## Service Information Bulletin

SUBJECT	DATE
SPN 3251 (ACM) (EPA10) and (ACM) (GHG14), 3936 (ACM) (EPA10;GHG14), and 5298 (ACM) (EPA10;GHG14)	March 2015

### Additions, Revisions, or Updates

Publication Number / Title	Platform	Section Title	Change
DDC-SVC-MAN-0084	EPA10/ GHG14 DD Platform	SPN 3251/FMI 2 - EPA10	These sections each have three additional steps added.
		SPN 3251/FMI 0 - GHG14	
		SPN 3936/FMI 18 - EPA10 - GHG14	
		SPN 5298/FMI 14 - EPA10 - GHG14

d500224

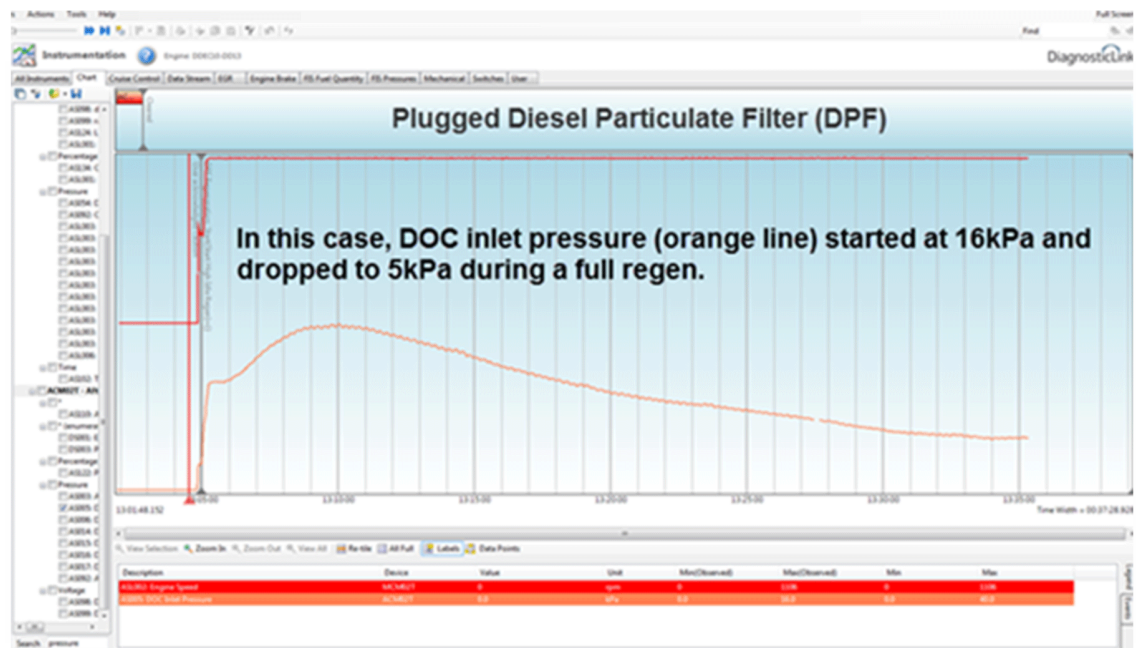
7. Start the engine and run a Parked Regen. Monitor DOC inlet pressure and engine speed during the regen. Compare your DOC inlet pressure reading to the screen shots below to identify a possible cause of the fault code.
  - a. If the DOC inlet pressure starts out high above 10 kPa (1.45 psi) and decreases during the parked regen, this indicates the DPFs were plugged and the parked regen cleared them. Go to step 8.

d500225

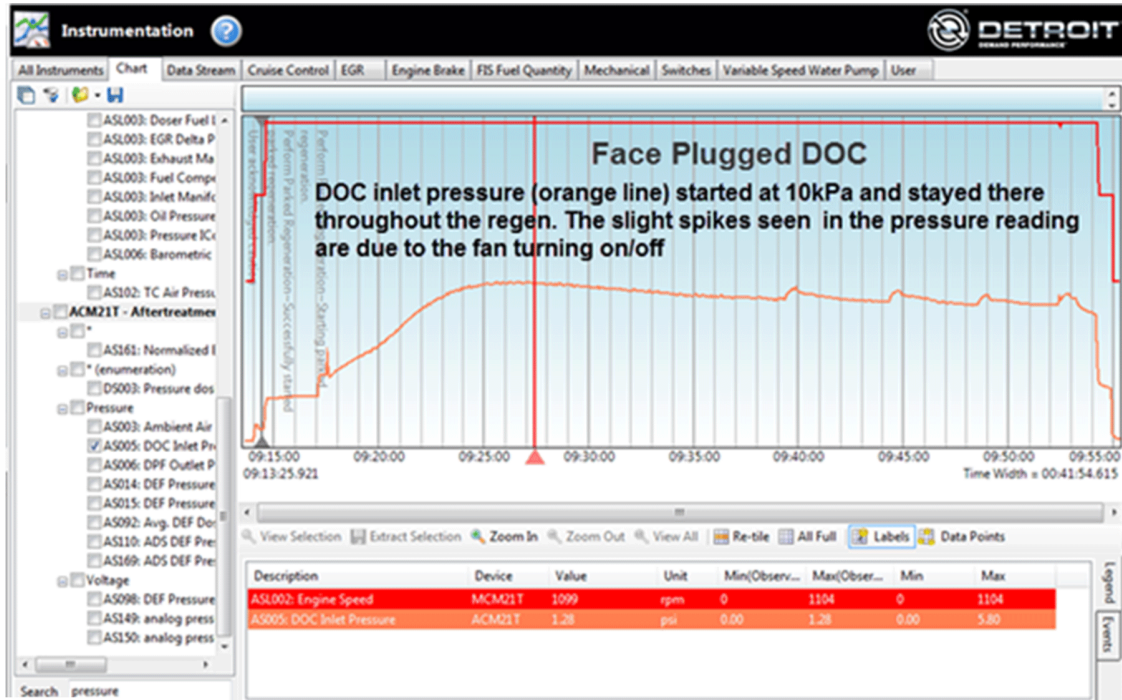
- b. If the DOC inlet pressure starts above 8 kPa (EPA10, 1.16 psi) and stays high, the DOC is considered plugged. Go to step 9.

d500224

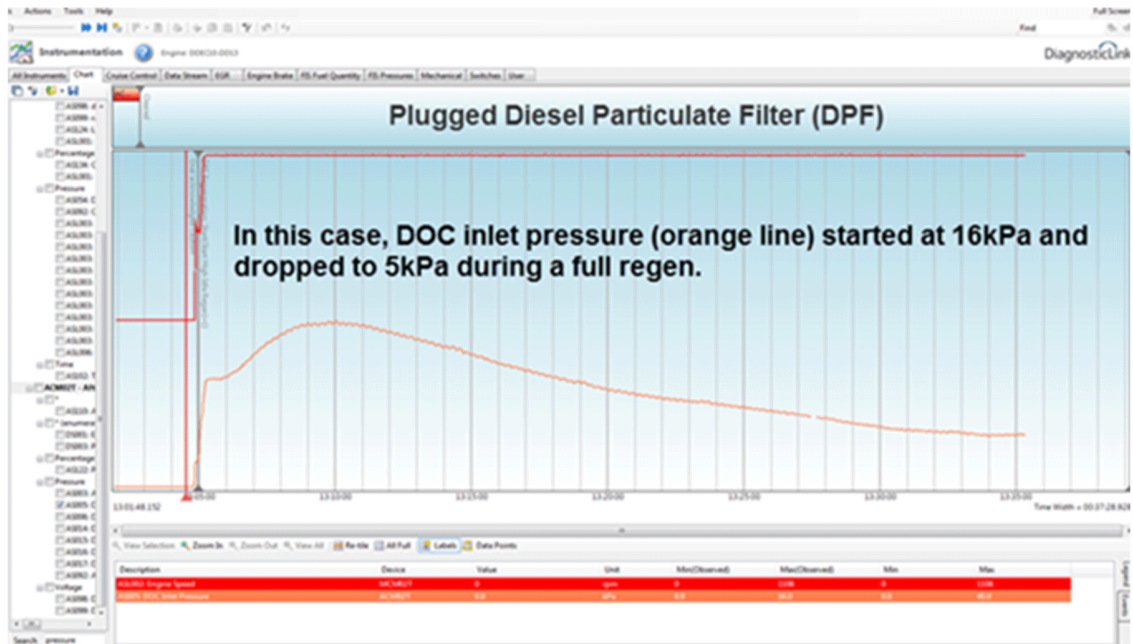
9. Start the engine and run a Parked Regen. Monitor DOC inlet pressure and engine speed during the regen. Compare your DOC inlet pressure reading to the screen shots and descriptions below in (a and b) to determine what step to go to next.
  - a. If the DOC inlet pressure starts out high above 10 kPa (1.45 psi) and decreases during the parked regen, this indicates the DPFs were plugged and the parked regen cleared them. Go to step 10.

d500225

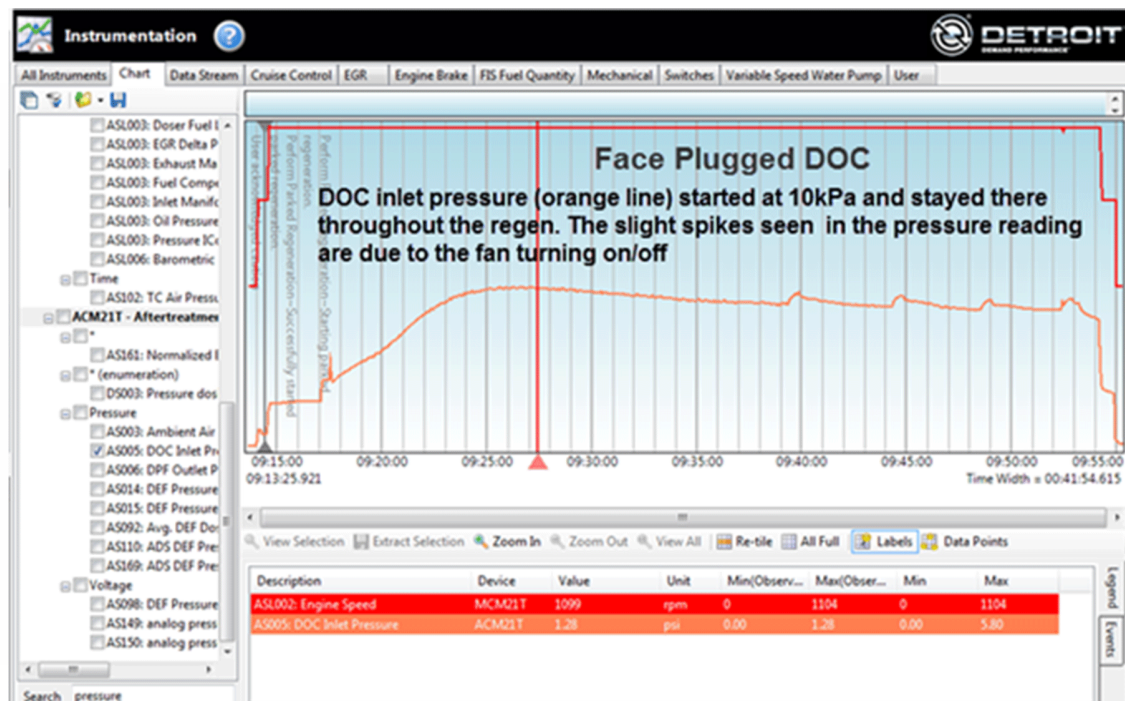
- b. If the DOC inlet pressure starts above 6 kPa (0.8 psi), and stays high, the DOC is considered plugged. Go to step 11.
